**TOWN OF PORTOLA VALLEY
ARCHITECTURAL AND SITE CONTROL COMMISSION (ASCC)
Monday, December 10, 2012
Special Field Meeting (time and place as listed herein)
7:30 PM – Regular ASCC Meeting
Historic Schoolhouse
765 Portola Road, Portola Valley, CA 94028**

TO: ASCC
FROM: Tom Vlasic, Town Planner
DATE: December 6, 2012
RE: Agenda for December 10, 2012 ASCC Meeting

Photo 16

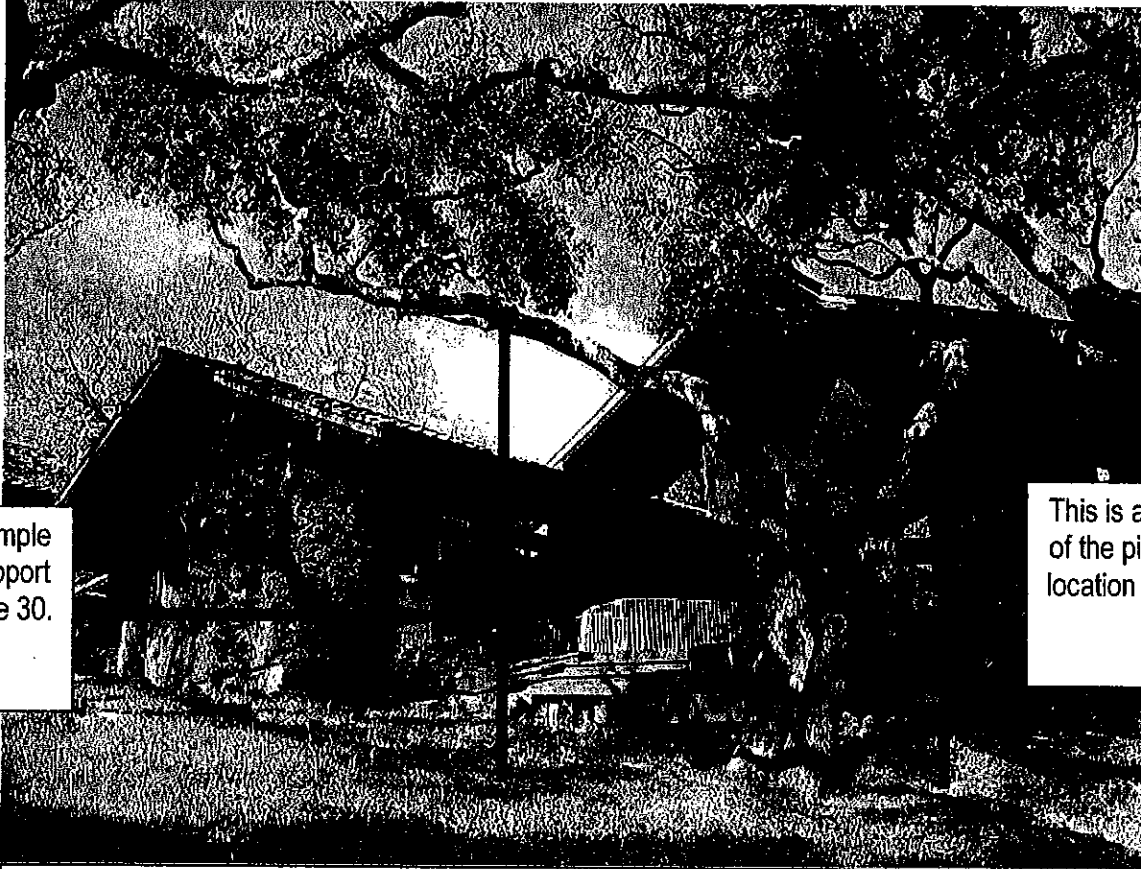
This is an example of the pipe support location on tree 30.

Photo 5 shows an example of a proposed location for the pipe supports for tree 30, the actually placement should be determined by the arborist performing the work. Examples are only for reference and should be considered actually locations!

Photo 12

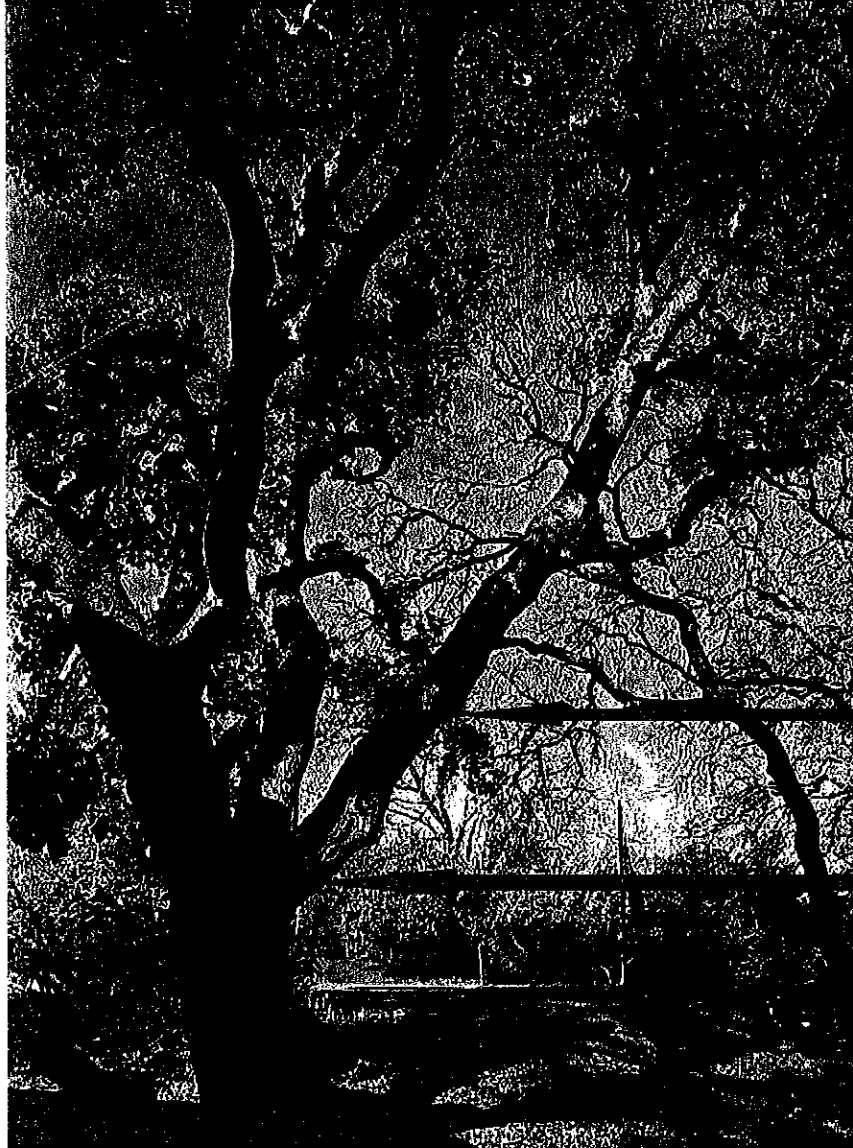
1. This tree requires removal of a major scaffold branch to provide clearance for the master bedroom (see photo 12). It is my opinion that removal of this limb will significantly alter the appearance of this tree however, I believe the tree can tolerate removal of this limb. Additionally, this tree has a cable attached to tree 9 to support the significant lean of the main trunk of tree 9 (see photo 13).
2. In addition, the foundation for the proposed master bedroom is located eight feet from the trunk and within the critical root zone of this tree.

This entire limb requires removal for clearance of the proposed master bedroom.
